Product Change Notification / ASER-25CMMA573

CCB 3192.009 Final Notice: Qualification of MMT as a new final test site for Micrel SY88903ALKGxx device family available in 10L MSOP (3x3x1.0mm) package.

CCB 3192.009
Pre and Post Change Summary
PCN# ASER-25CMMA573

Packing Information Tape and Reel

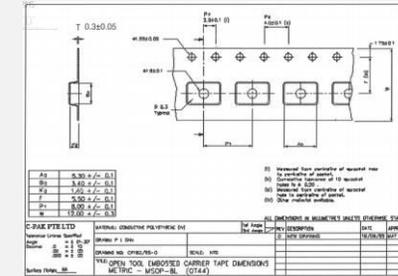
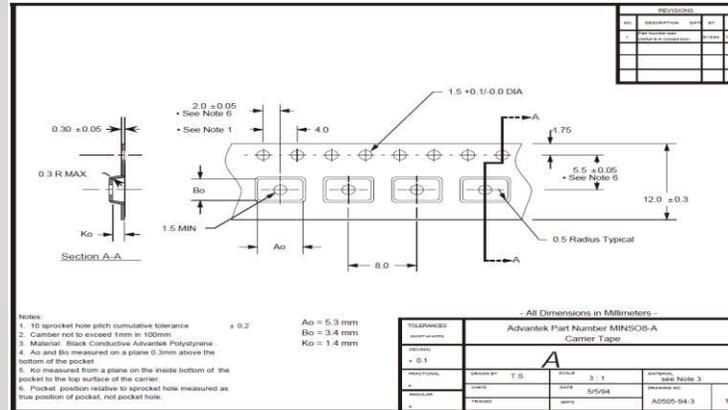
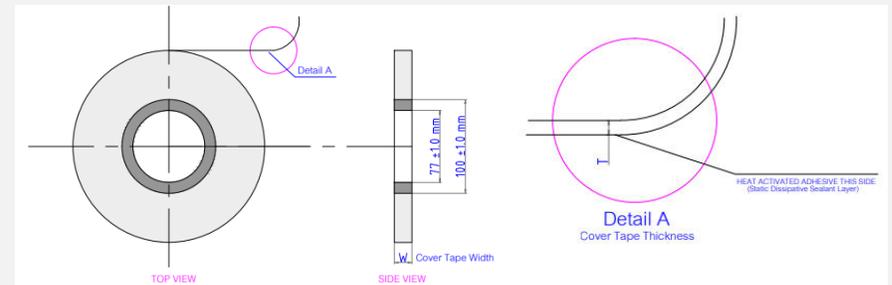
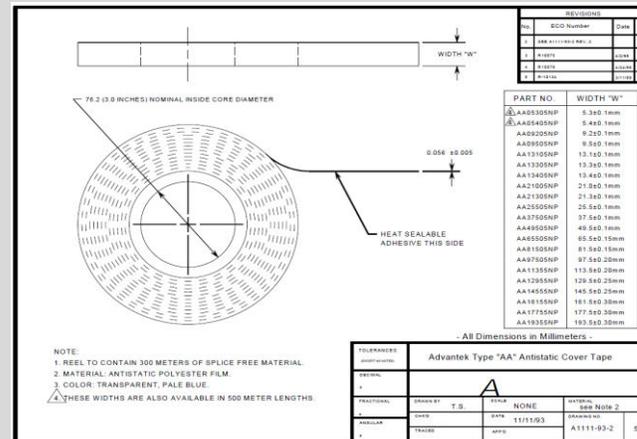
Base Quantity Multiple (BQM)	Tube	100	100
	Tape and Reel	2500	2500
Pin 1 Location	Tube	White plug side	White plug side
	Tape and Reel	Quadrant 1	Quadrant 1
Tube Plug Colors		White and Black	White and Black
Reel Color		White	Dark blue
Carton Box	Tube	Minor dimensional changes – see Pre and Post Change attachment.	
	Tape and Reel	Minor dimensional changes – see Pre and Post Change attachment.
